# ADDENDUM # 3

Reference: Department of Alcoholic Beverage Control New Riverton Liquor Store – DFCM Project No. 05053030
Kimball Junction Liquor Store Remodel & Addition – DFCM Project No. 06234030
Redwood Road Liquor Store Remodel & Expansion – DFCM Project No. 06233030

**Addendum No. A03**

**PROJECTS**
**Department of Alcoholic Beverage Control**
**New Riverton Liquor Store - DFCM Project No. 05053030**
**Kimball Junction Liquor Store Remodel & Addition - DFCM Project No. 06234030**
**Redwood Road Liquor Store Remodel & Addition - DFCM Project No. 06233030**

A
101r

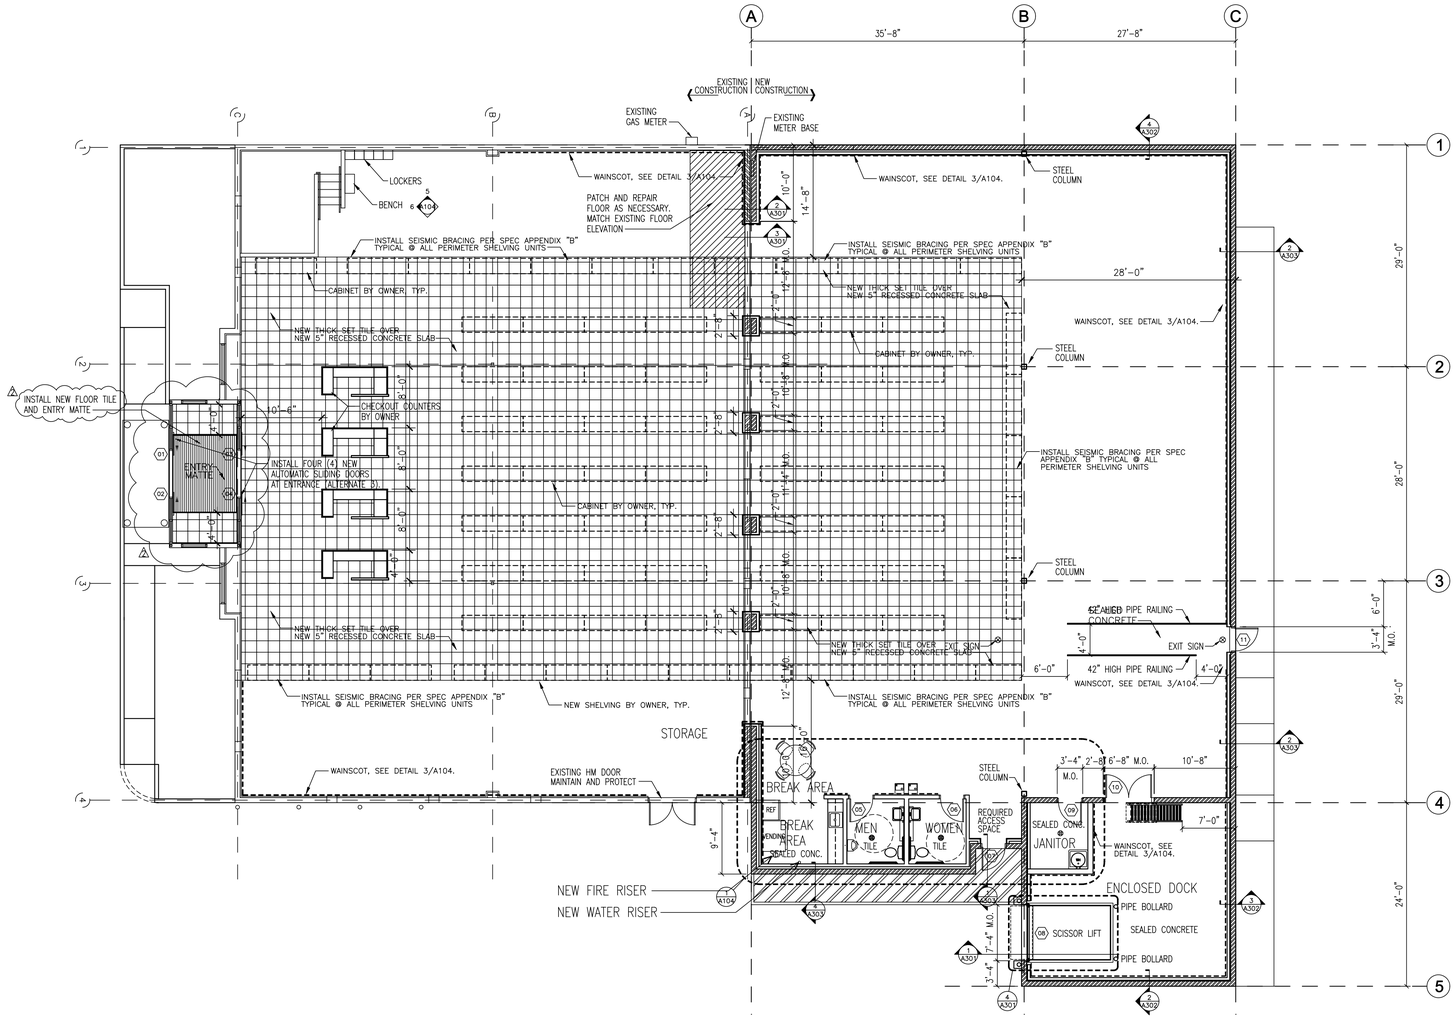
1. PROVIDE SIGNAGE ABOVE ENTRY DOORS STATING "THESE DOORS TO REMAIN UNLOCKED DURING BUSINESS HOURS".
2. PROVIDE SIGNAGE DESIGNATING "PUBLIC RESTROOMS" AT LOCATION TO BE DETERMINED BY ARCHITECT.
3. CONTRACTOR TO PROVIDE AND INSTALL 25 L.F. OF CHAIR RAIL (INPRO CORP., NORTHERN HARDWOODS CR2 OR EQUAL) IN LOCATIONS AND AT HEIGHTS TO BE DETERMINED BY THE ARCHITECT.
